HILLIARD PLANNING AND ZONING BOARD MEETING

TUESDAY, NOVEMBER 04, 2025, 7:00 PM

ITEM-5 Planning & Zoning Board approval of Site Plan Application No. 20250808.1. Parcel ID # 08-3N-24-2380-0011-0012. Applicant- Kim Seyer, The Seyer Group.
Lee Anne Wollitz -Land use Administrator

SHEET NUMBER C-6.0

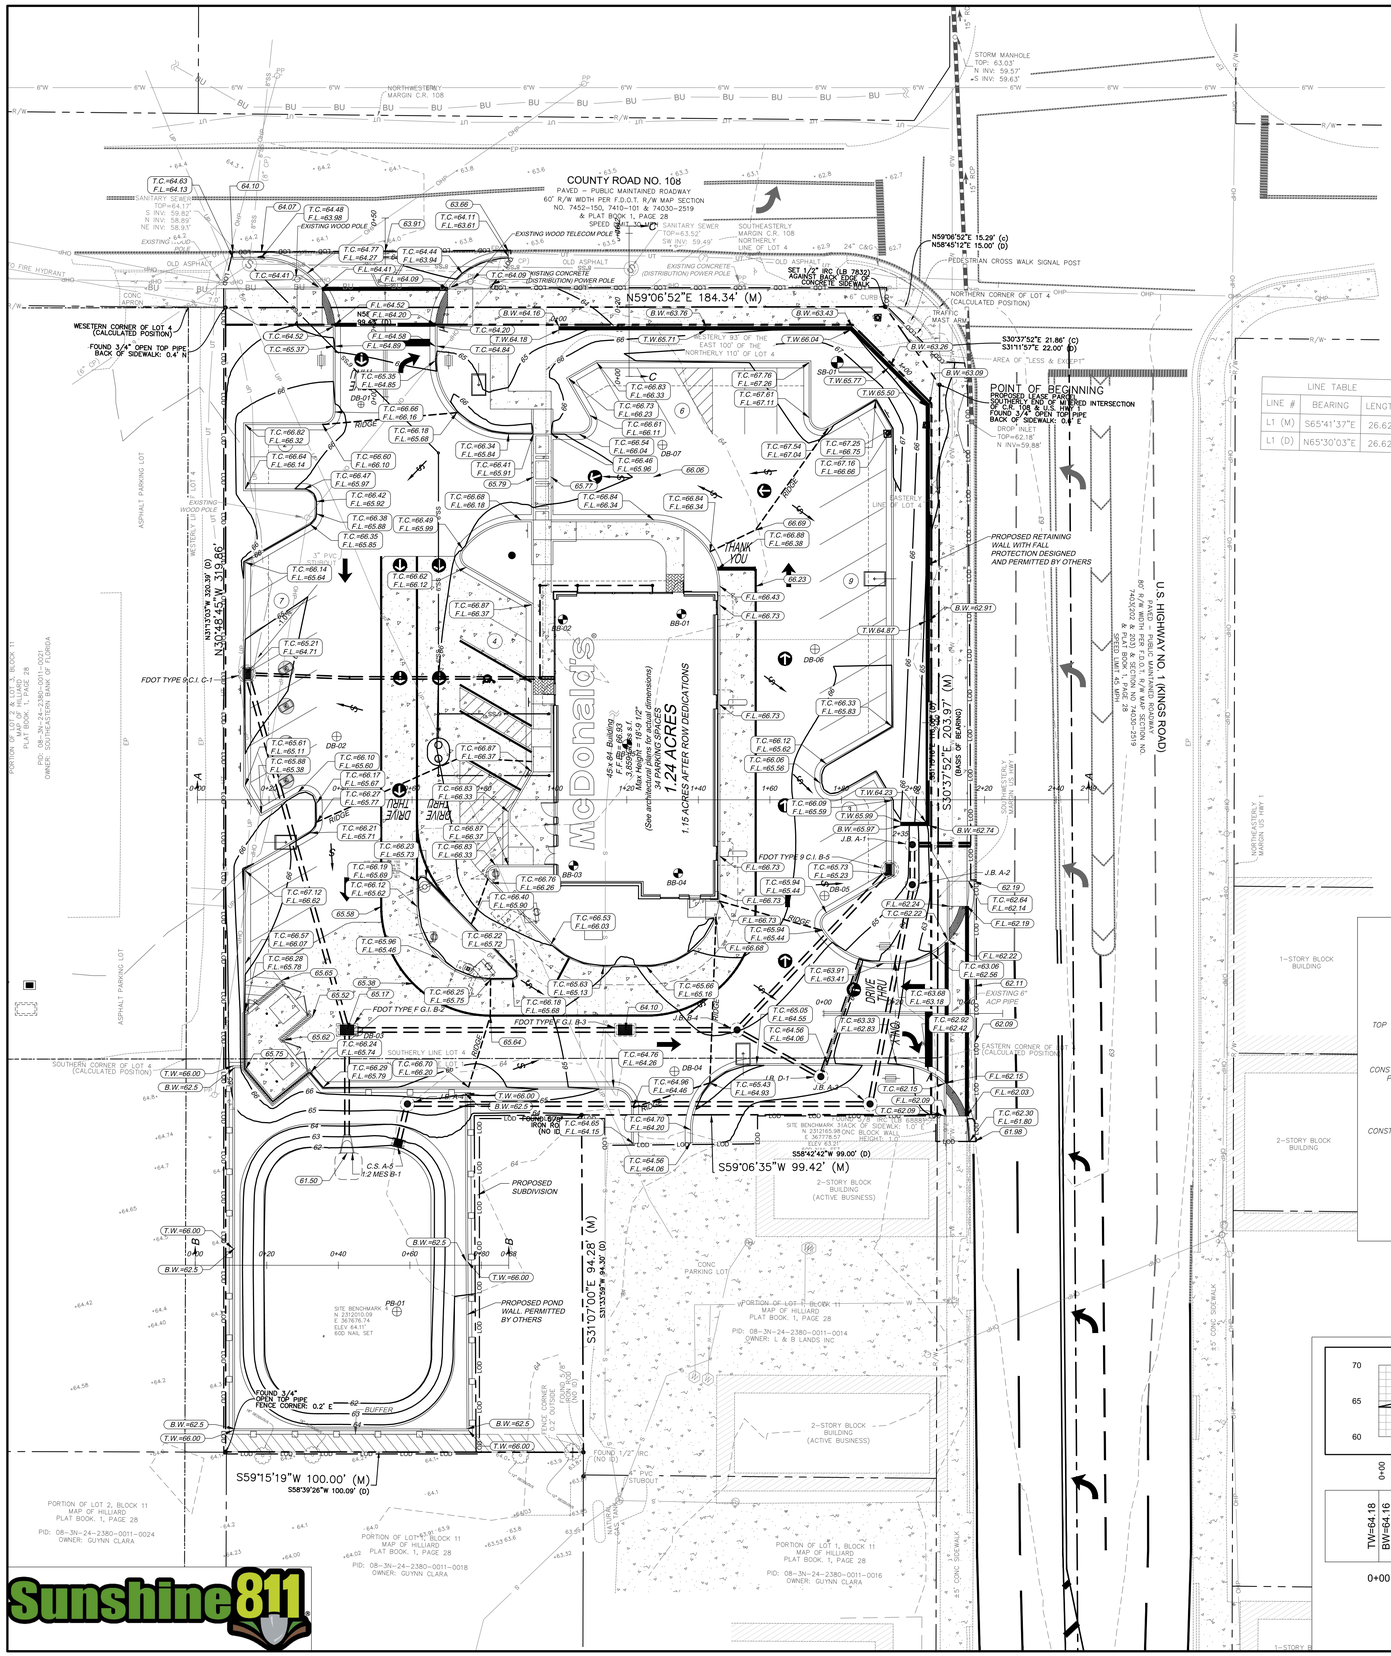
8. Grading and Drainage Notes shall be worded as they appear in the SWPPP notes on sheet C-3.0. Grading Phasing notes added to sheet.
9. In the wall profile is there a reason that the top of wall is not an even surface as opposed to having the two dips in the middle. Slope modified to be more uniform across the wall

10. The wall will require a separate permit with the Town’s Building Department. Ok
11. Label the 3 storm pipe runs and reference them to sheet C-7.1 for more detail. Note added to reference pipe C-7.1 for pipe run profiles.

SHEET NUMBER C-7.0

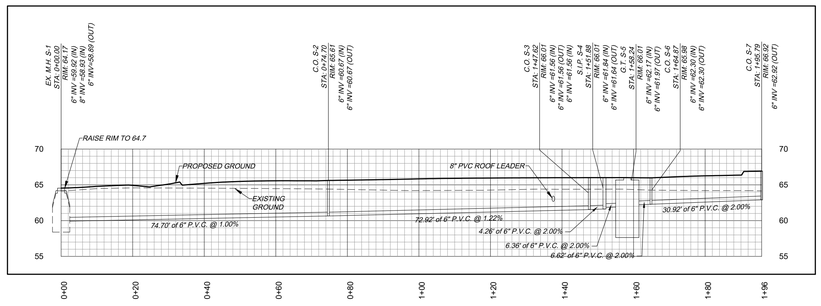
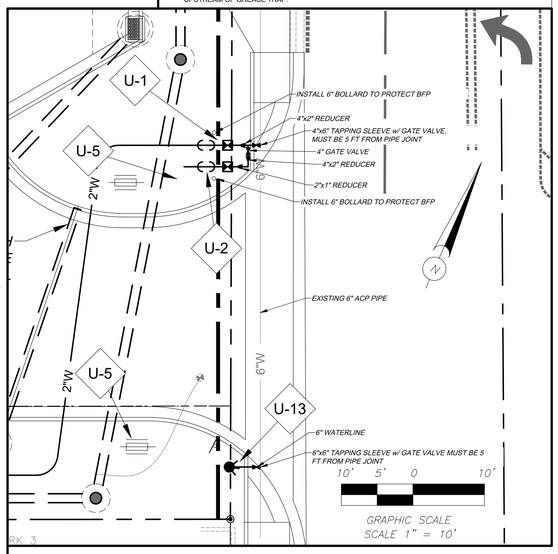
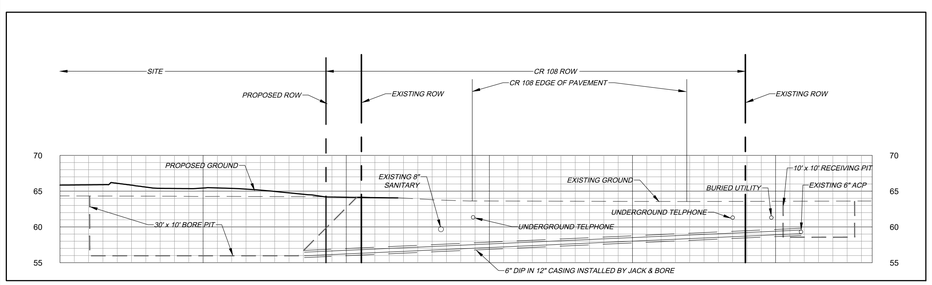
1. Raise the rim of the sanitary manhole that the sewer lateral is connecting to be at or above the top of curb elevation shown on sheet C-6.0 (64.48). Added note to raise RIM to 64.7

2. The proposed Ex. MH S-1 data does not correspond to the survey data from the Atwell topo survey, sheet C-6.0, or as shown on this plan sheet. Ex MH S-1 shows a rim at 64.32 and the survey data shows 64.17. Please correct appropriately. Corrected

7. Recommend a backflow device on the water service to the dumpster. Added note to Utility callout U-16*
8. Provide the diameter of the Town's existing water main in the US 1 ROW. On sheet C-4.0 there is a note that the COR is to soft dig a pothole over the existing 6-inch asbestos cement water main in the US 1 ROW. Changed linetype and added label

18. Utility Notes #7 shall reference the Florida Trench Safety Act in the first sentence. Added
19. Utility Notes #8 shall also include the Town in the approval of substitute materials. Added
20. Provide the material spec for the on-site water mains (U-3). Added
21. The sanitary sewer lateral shall be SDR 26 from the building to the connecting manhole (U-8). Added
22. The roof leader shall be SDR 26 (U-17). Added
23. Is there a reason to repeat the Project Notes on this sheet since they are already printed on sheet C-5.0. Recommend deleting them from sheet C-7.0. Yes, for reference for the contractor.

STORM SEWER A SYSTEM PROFILE

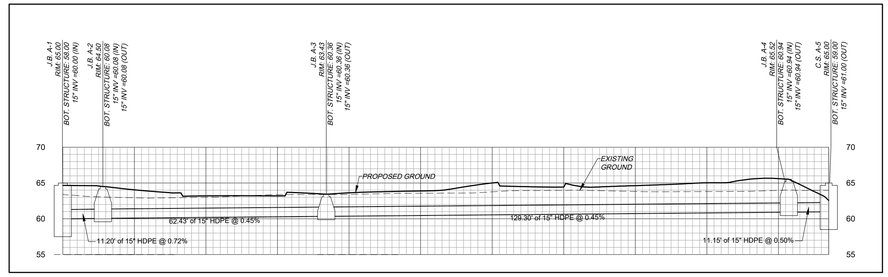
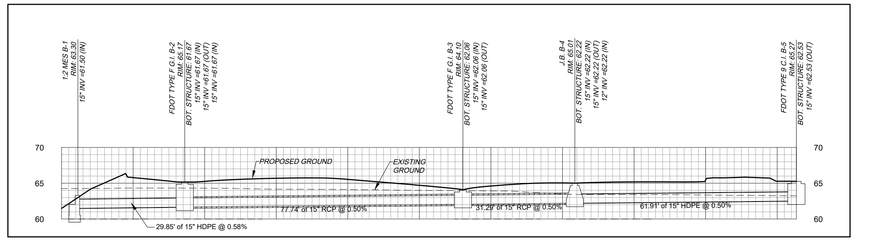
1. Notes #2 shall also reference the Florida Trench Safety Act. Added
2. The rim elevation for the existing Town manhole is incorrect. As shown on the sheet C-2.1 the surveyor stated the rim is 64.17. Corrected

POND OUTFALL DETAIL
STRUCTURE J.B. A-1
MANHOLE TYPE P-7 W/ SUMP
FDOT INDEX NO. 425-001 AND 425-010

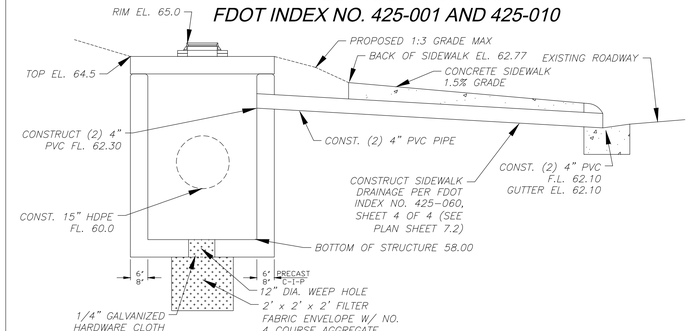
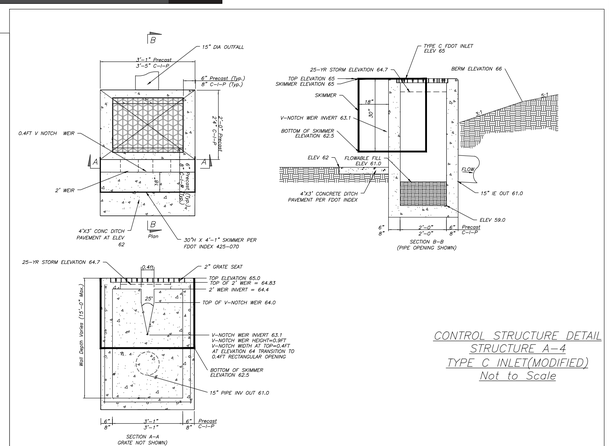
1. Pond Outfall Detail A-1 will require an FDOT permit to discharge into the curb on US 1. We are pursuing this concurrently.
2. Is there to only be one downspout for the building and it will only be 3-inches in diameter? Or is there to multiple downspouts that discharge into a header pipe that directs the runoff to the storm system? The multiple downspouts and the header pipe need to be shown on sheet C-6.0. There are multiple canopy downspouts that were not shown but are now, there is a single roof drain from the building
3. Storm Drain Pipe Bedding shall be per the FDOT standards as opposed to "GADOT." Updated
